Site Plan Review Committee (SPRC)  
Staff Report for:  
**Marbella Apartments (Site Plan #463)**

**SITE PLAN REVIEW COMMITTEE  
MEETING AGENDA**

**Item 1. Marbella Apartments** **7:00pm–9:00pm**  
(RPC#s 17-033-006, -009, -016, -017)  
Planning Commission and County Board meetings to be determined.  
*Michael Cullen (CPHD Staff)*

**Figure 8E: Existing Condition and Proposed Rendering – view from Westmoreland Terrace (looking southwest)**

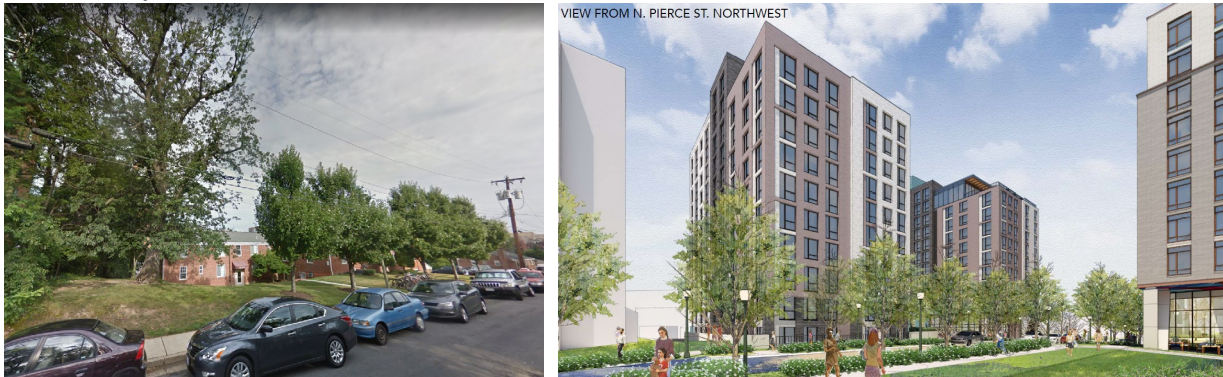
The project proposes two twelve story buildings, each of which focus building taper down to 11- and 10-stories along N. Pierce Street and the northern property lines, with slight building step-backs above the bottom 1-2 floors on portions of each building footprint. Graduated building heights and setbacks are two key mitigation criteria outlined in the Section 15.5.9 provision for bonus building height; however, those criteria are not defined or detailed beyond the language provided in the ACZO. To that end, staff will provide supplemental analysis during

the public review period of this project that may be used to evaluate building transitions to lower density neighborhoods during consideration of additional building height in RA districts.
